## ADDENDUM NO.3

**PROJECT:** Cumru Fire Department  
**ADDRESS:** 1775 Welsh Road  
Mohnton, PA 19540

**MWS PROJECT NO:** 18-036  
**DATE:** 1/19/2024

SHEET NUMBER:  
**A103**

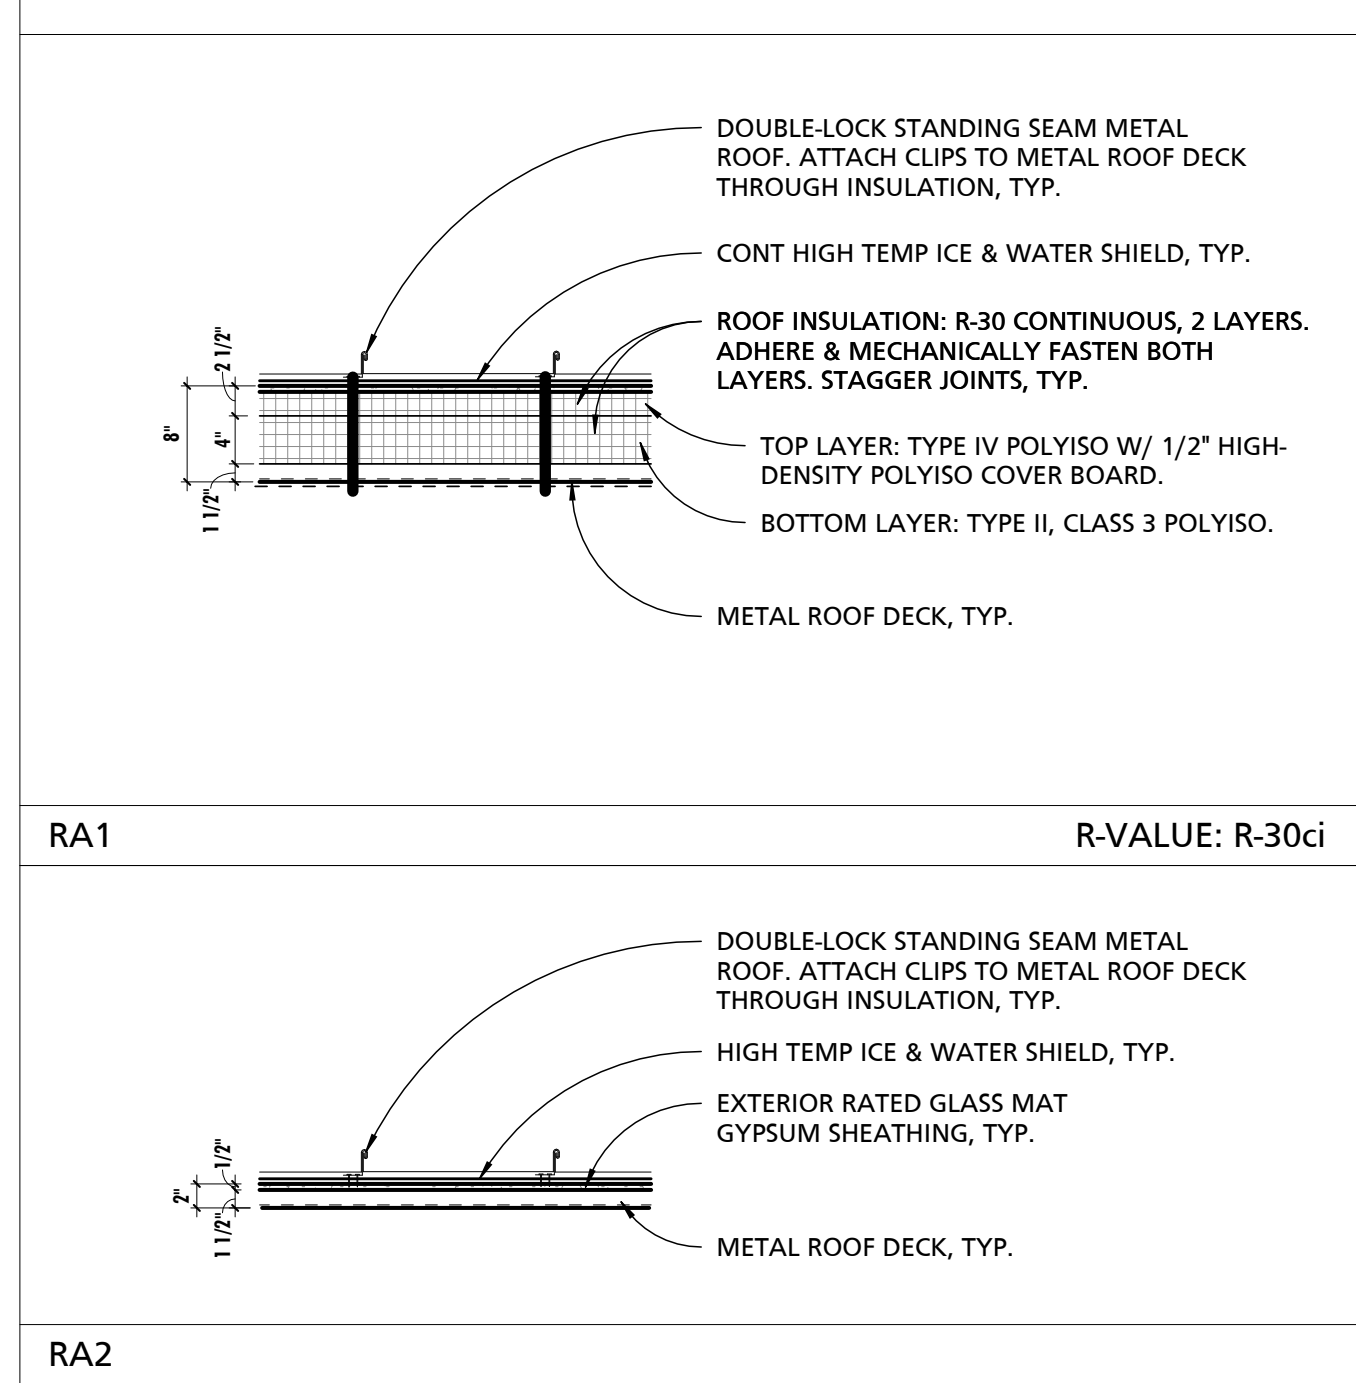
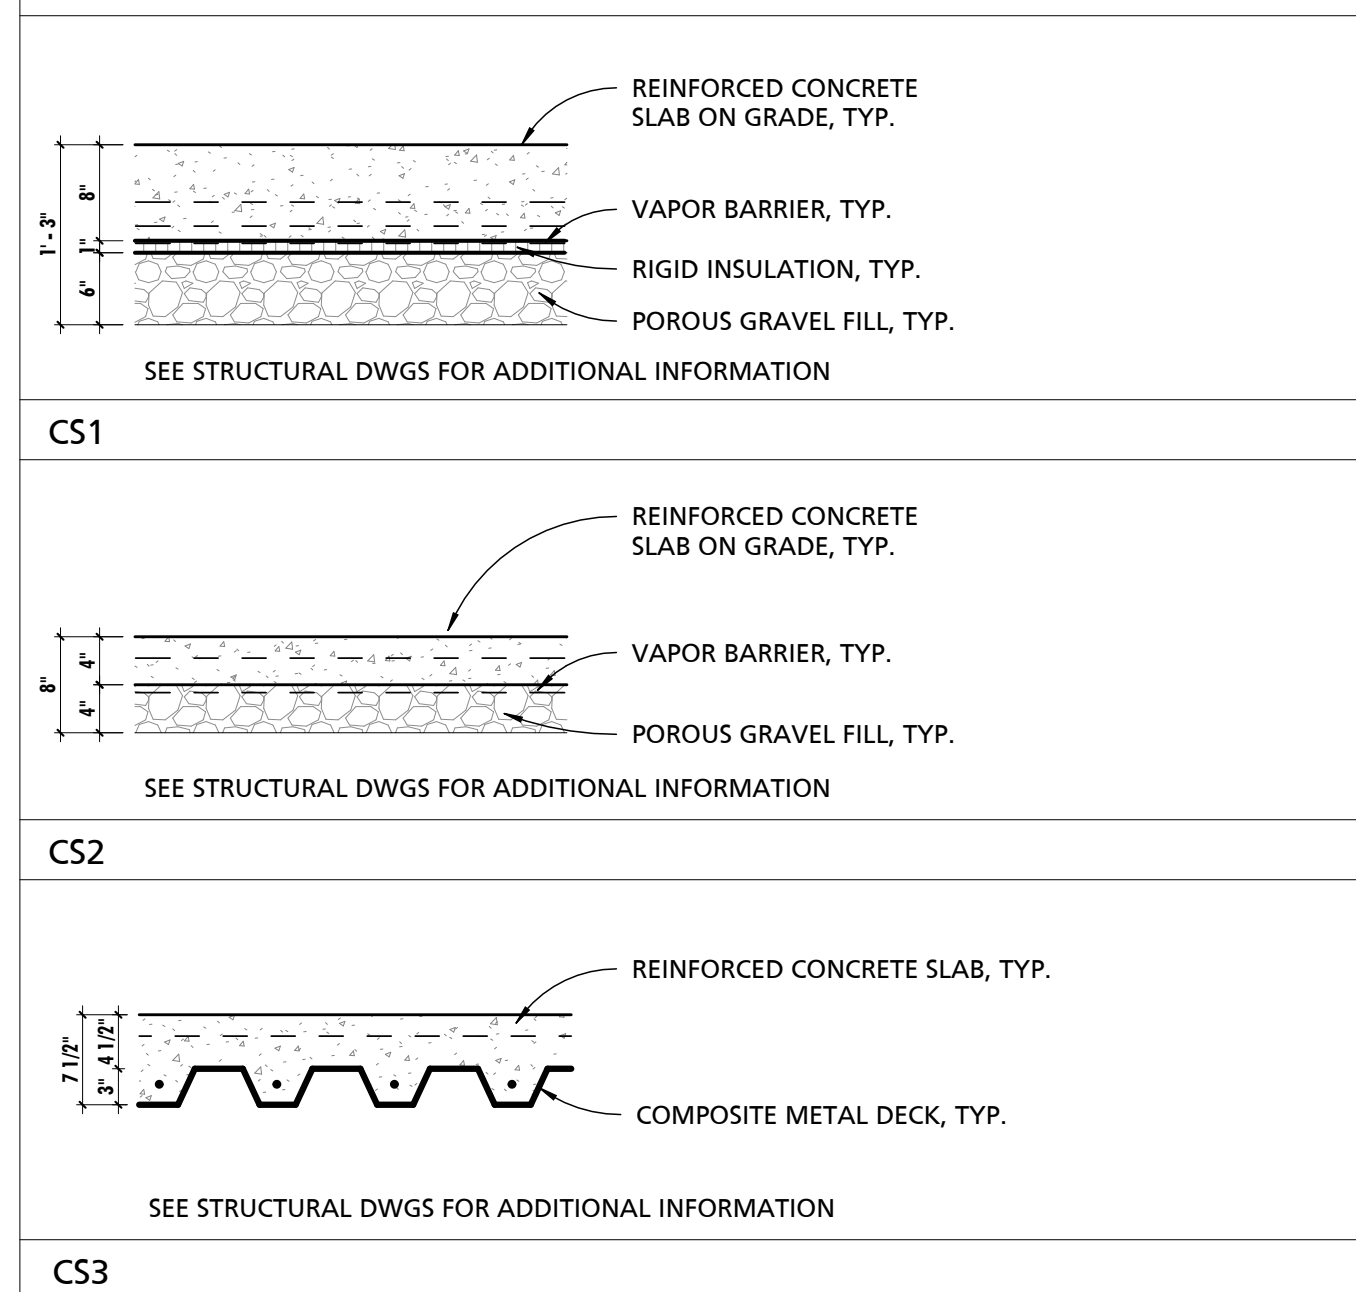
**17.) QUESTION:** General partition note 1 on page A103 says to install impact resistant gyp at entry's, lobby's and corridors. In corridor 131 does impact gyp need to go all the way to top of clerestory? Typically this would only go up to 8' then change to standard drywall. Please advise.

**RESPONSE: Impact resistant GWB to provided up 8' A.F.F within indicated areas.**
